Microsoft Ireland

DUB14-15

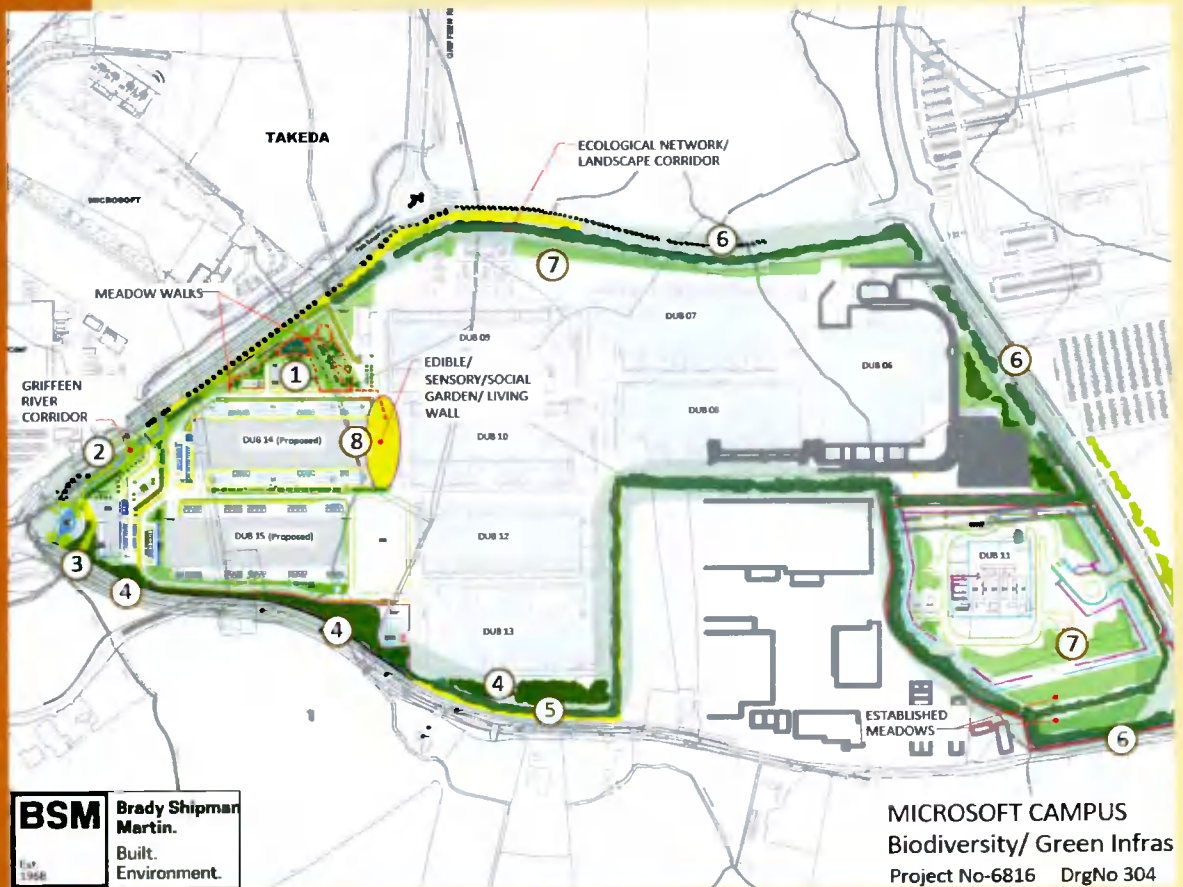
Date of RFI: 13th September 2021
